RFT 26-083 Interior Renovations & Air Conditioner Upgrades at Frontenac PS

The following, issued by the Halton District School Board (HDSB) June 18, 2026, shall be incorporated in the specifications and shall form part of the proposal document for the above.

TENDER ADDENDUM NO. 1
2026.06.17

Interior Renovations and Air Conditioner Upgrades at Frontenac Public School
Halton District School Board RFT 26-083
5140 Pinedale Avenue, Burlington, Ontario

Drawing No.:
A1.0

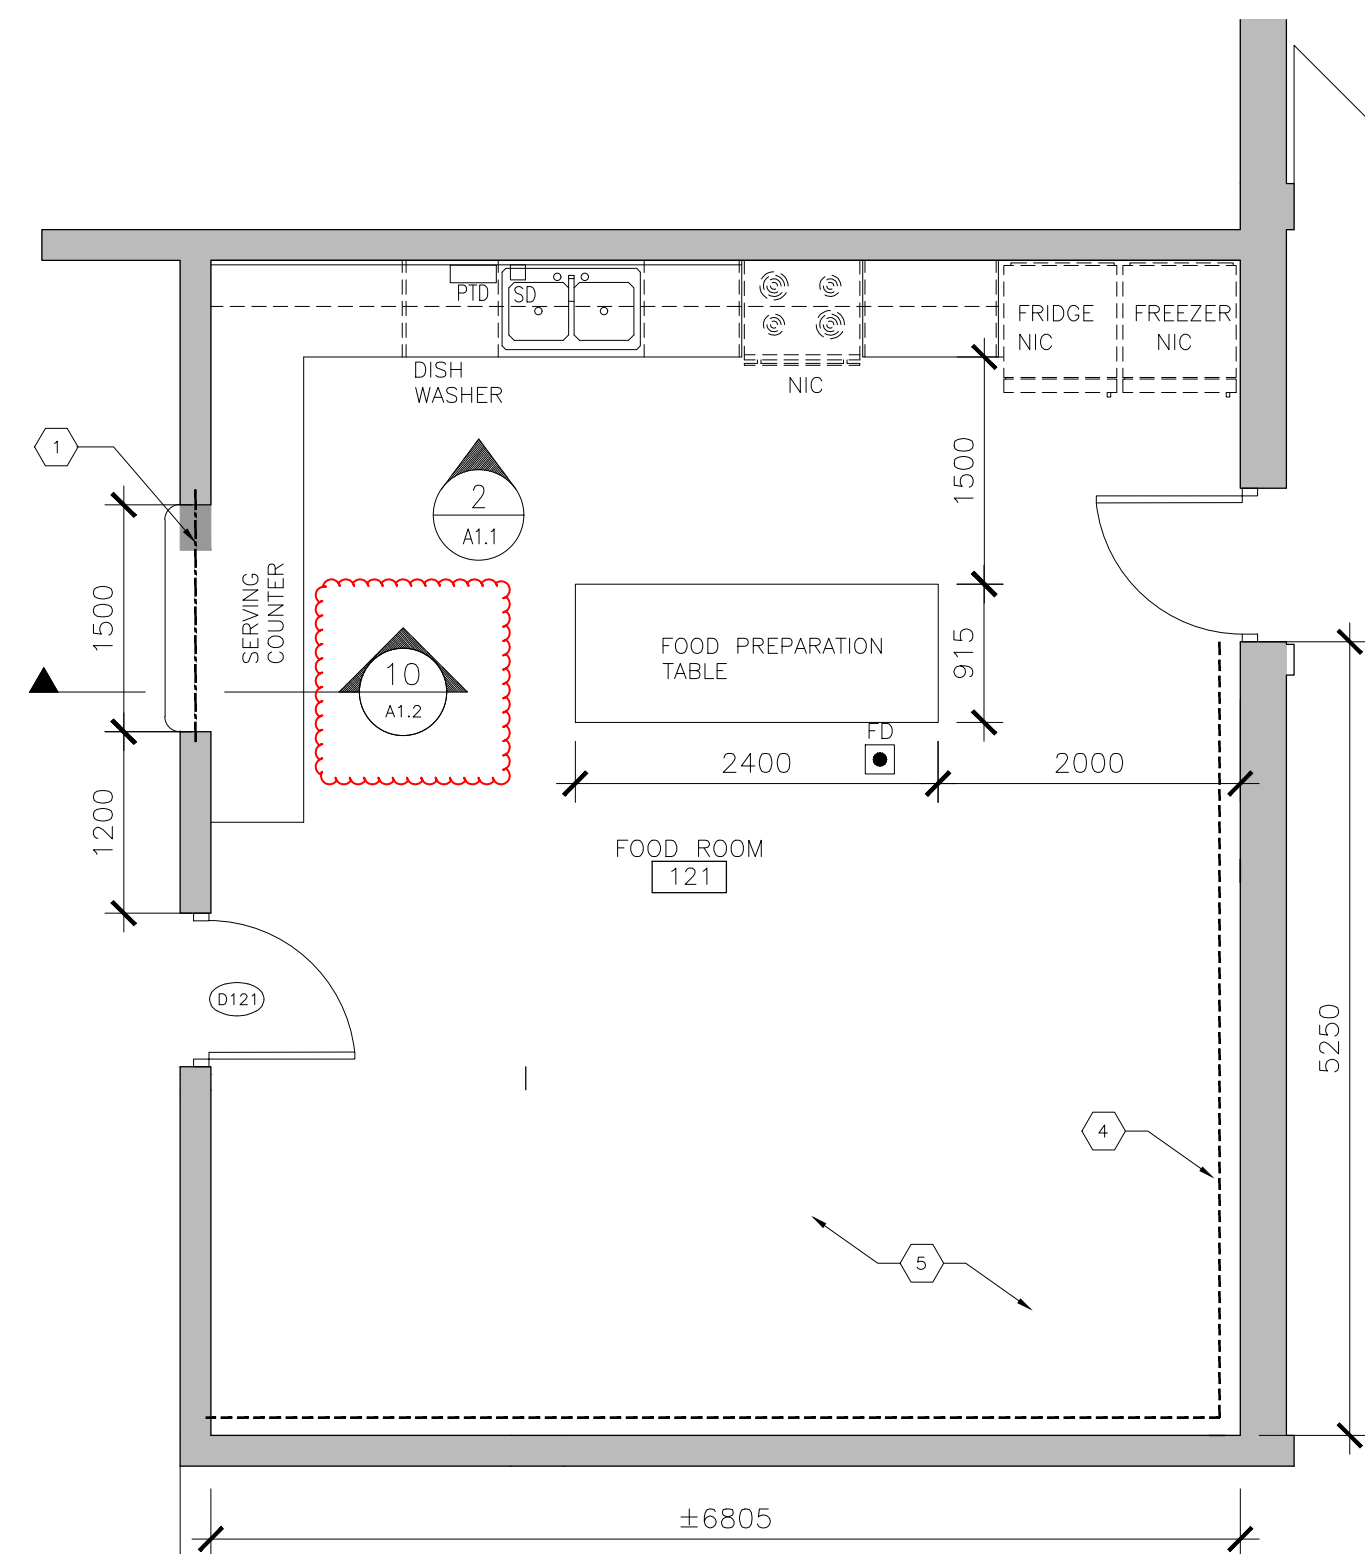
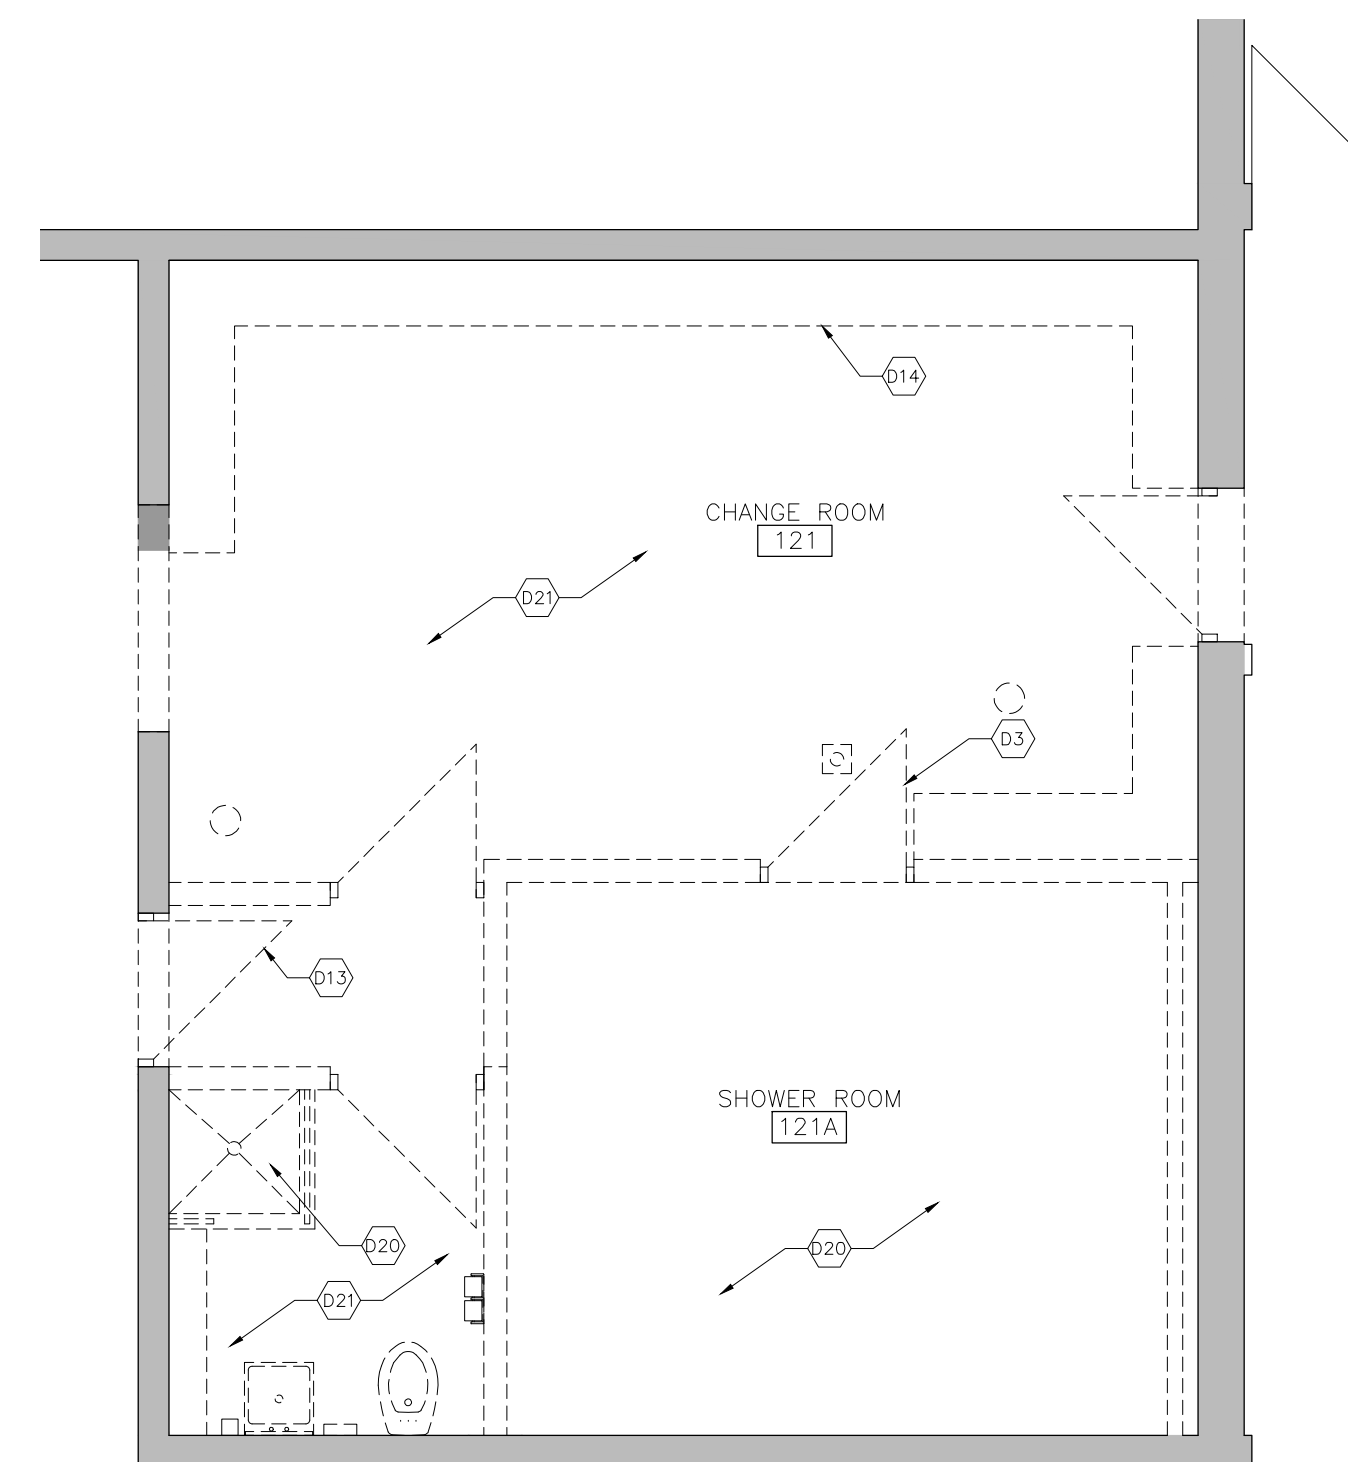
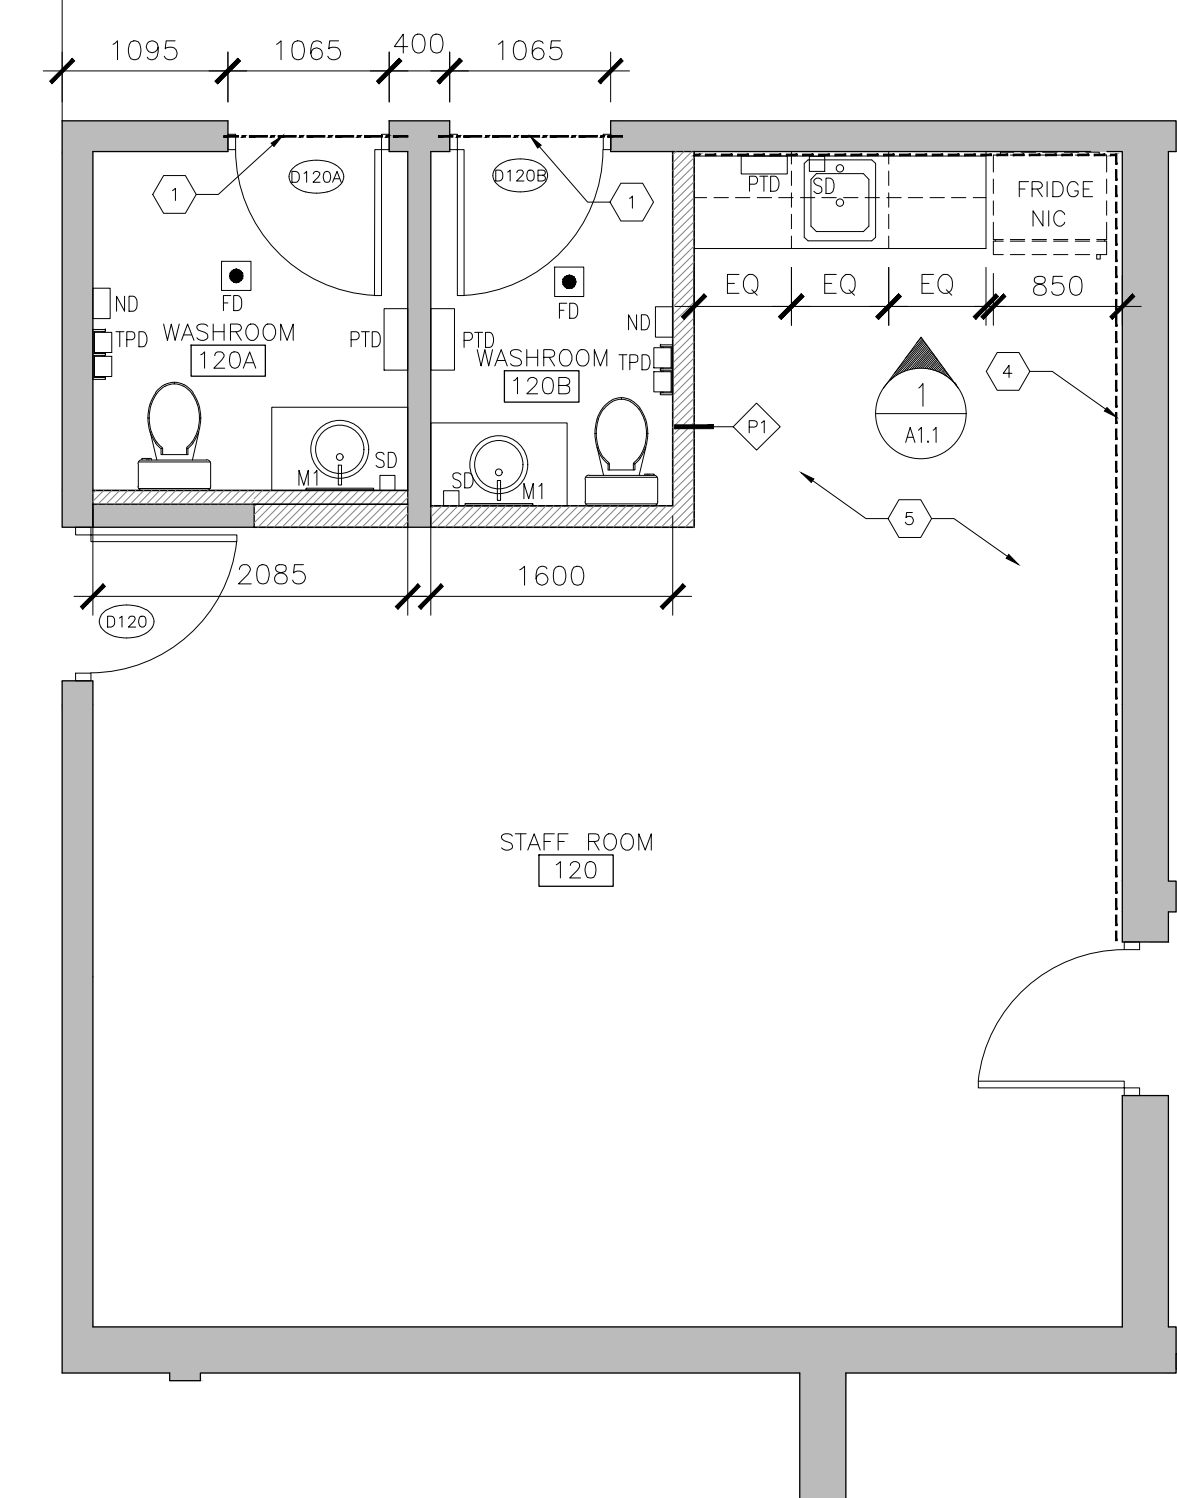
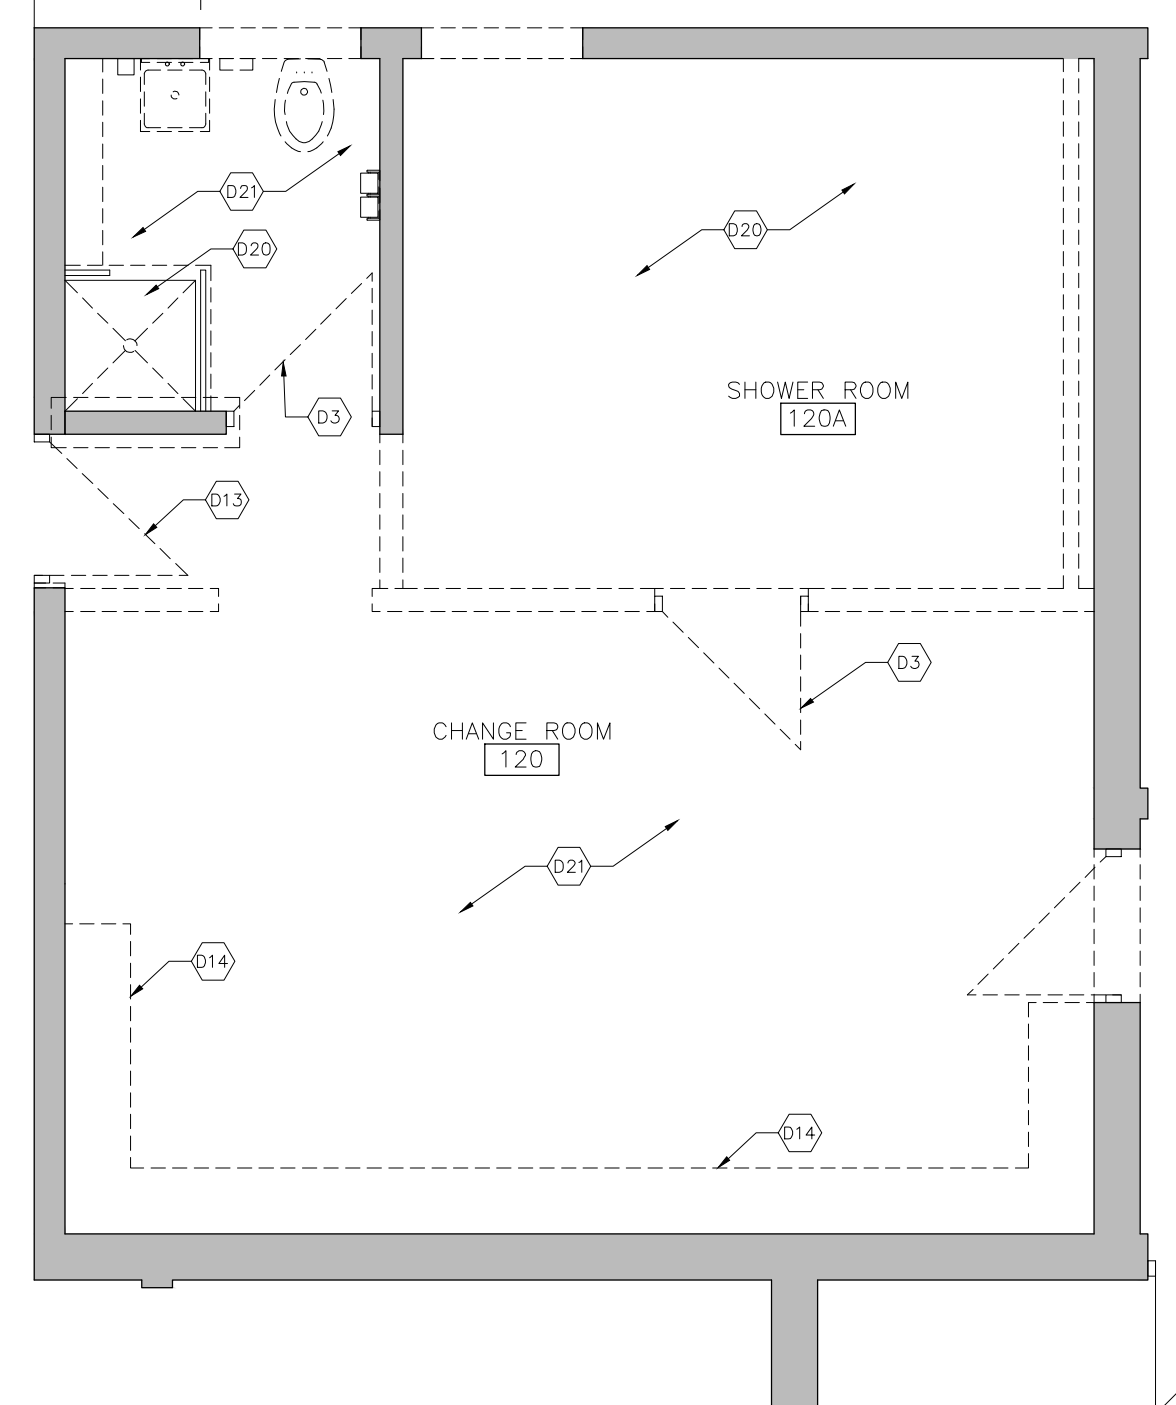
1.2: Drawings 2/A1.0, 4/A1.0, 5/A1.0 and 6/A1.0 Proposed Plans and Interior Elevations:

1. ADD reference bubbles to detail millwork sections. See attached revised drawing A1.0 with bubbled revisions.
